GROUNDWATER PROTECTION STUDY

Prepared for:
Virgin Town
114 Mill Street
P.O. Box 790008
Virgin, UT 84779

Third Party Comment & Review Letter Correspondence

RE: Virgin Town Groundwater Protection Study - Peer Review Response

REV. NO.	DESIGNED	DRAWN	CHECKED	SHEET NO.	
09817	DY	DSA	DSA	06 of 06	FIG. 6

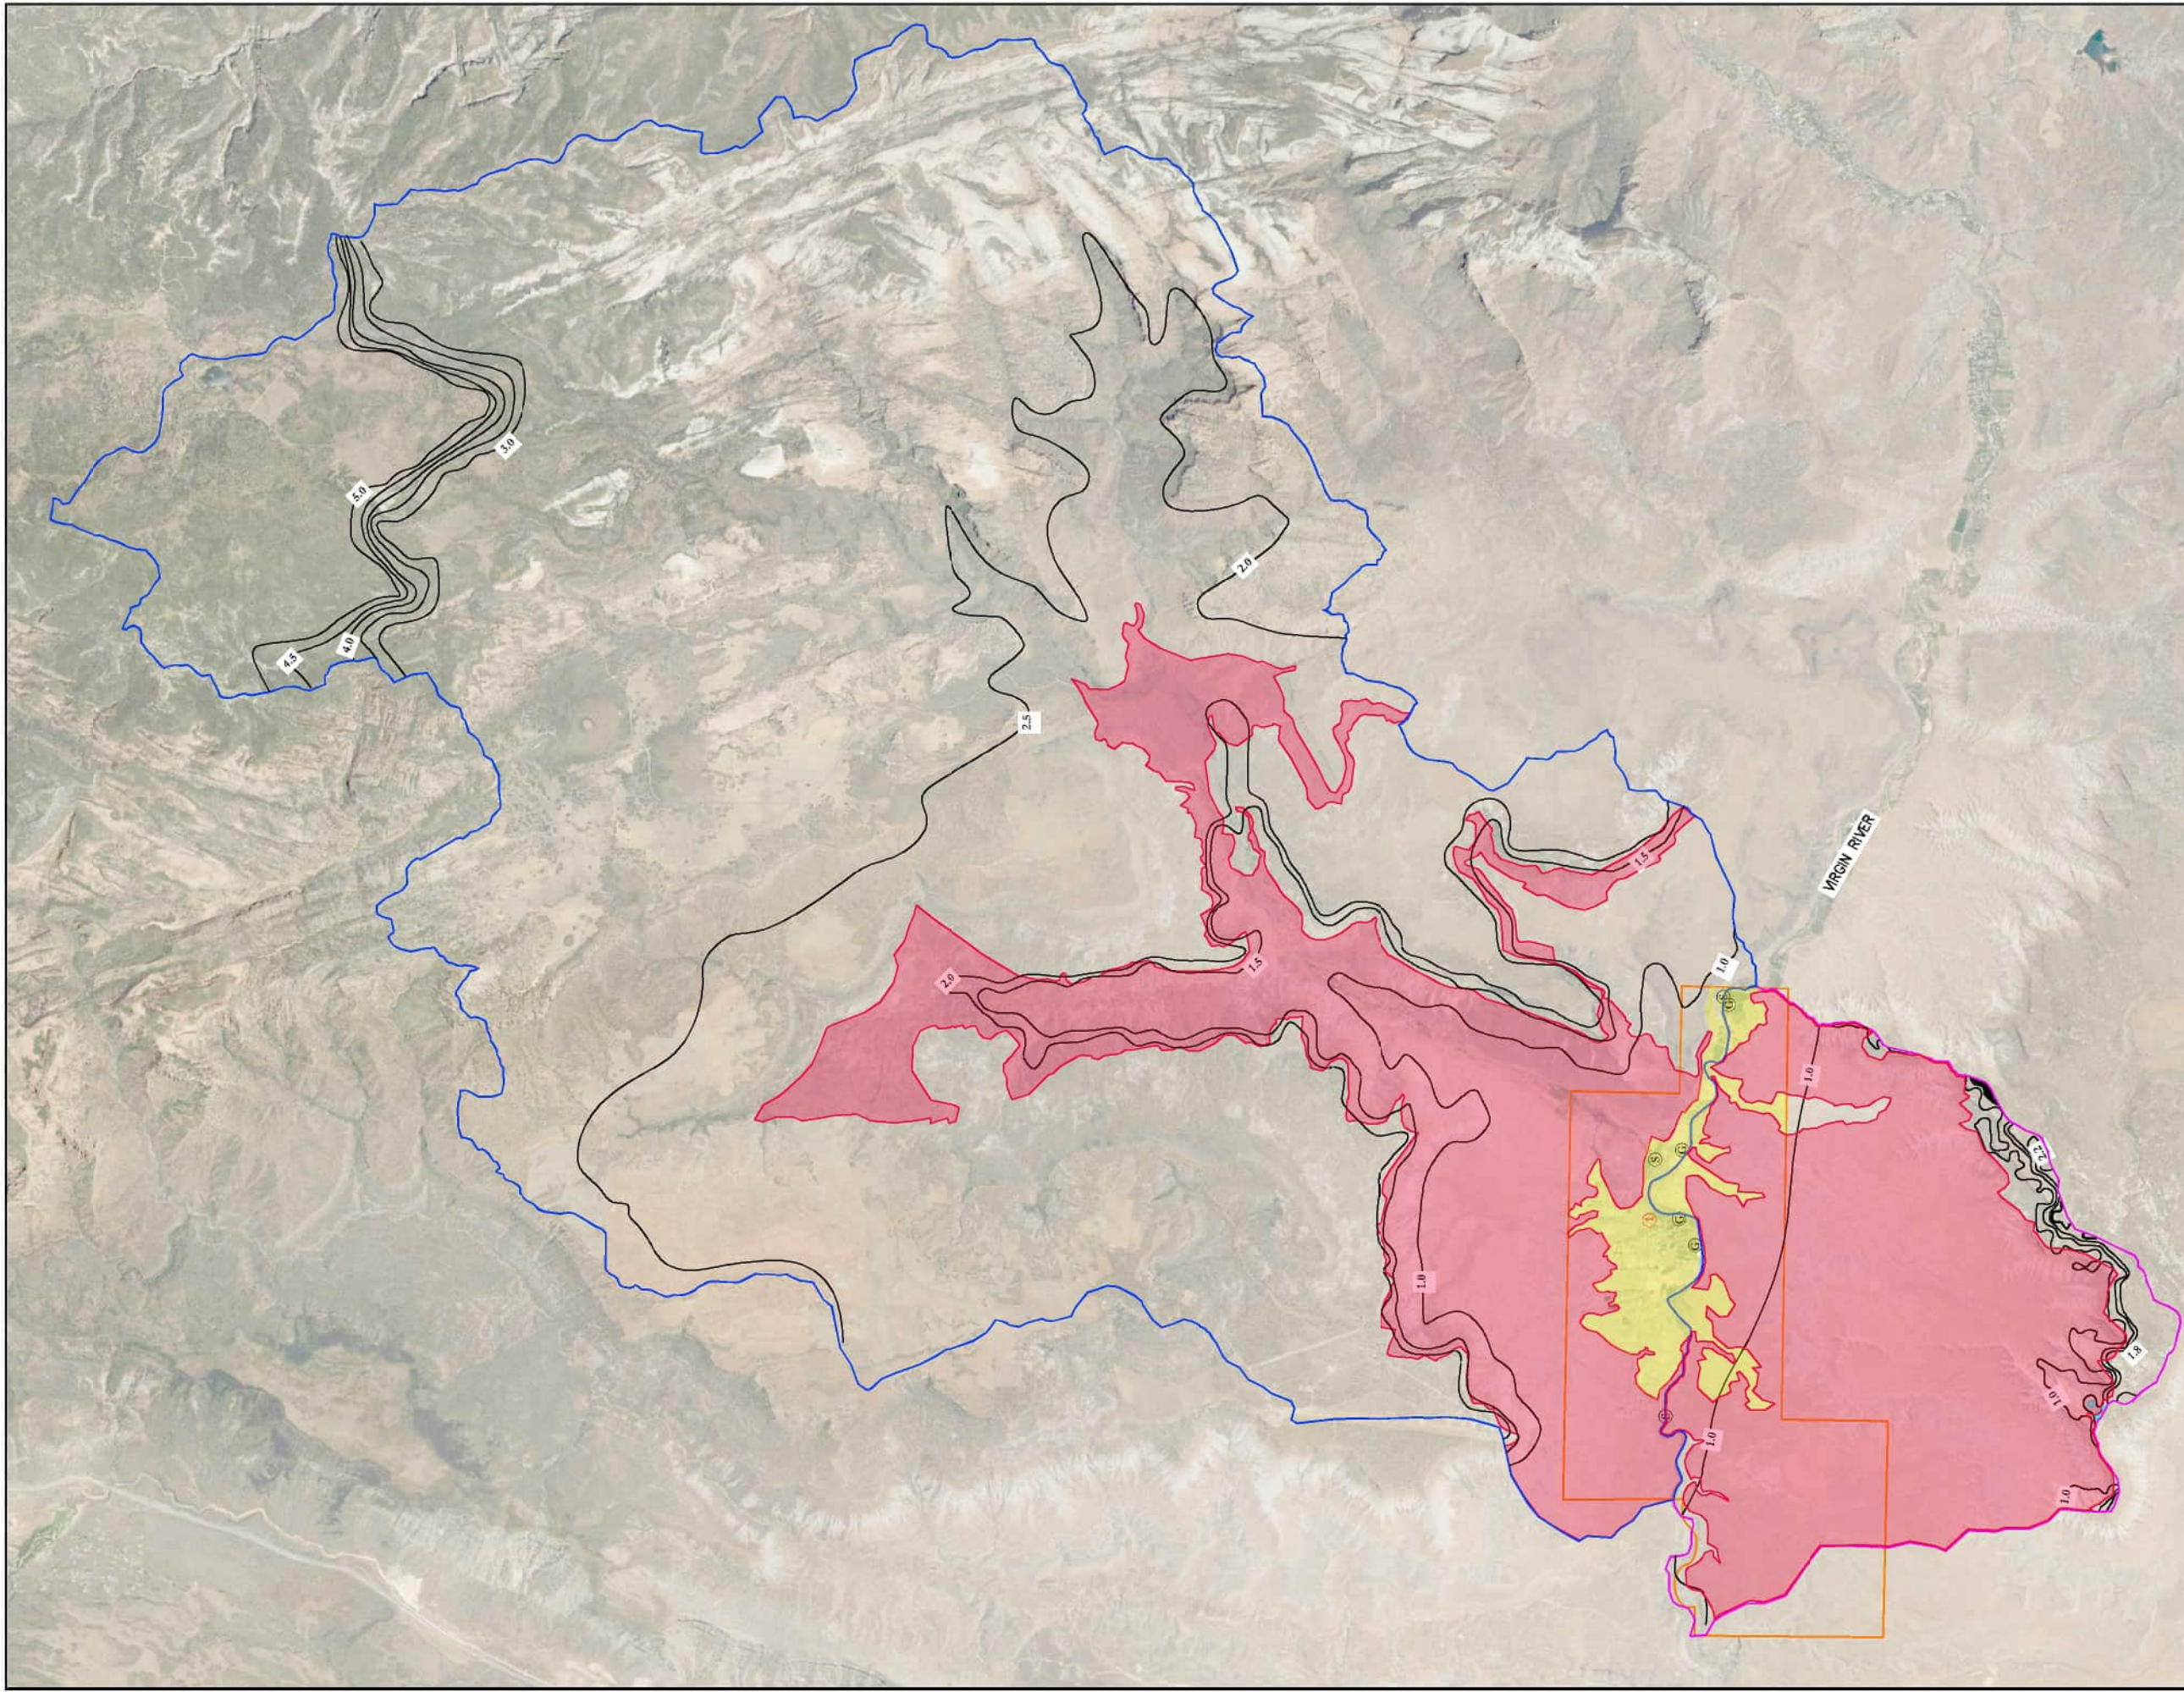
1. What is the reason for the feature with many contour lines near the northern extent of the figure, values 3.0 to 5.0?

4. Figure 6 is hard to interpret, particularly within Virgin Town itself. Adding a focus map/figure with a closer view of town limits would be helpful.

Response: This area is just below Goose Springs reservoir and south of Kolob Terrace Rd. The tight spacing of the recharge contours within this area are tighter
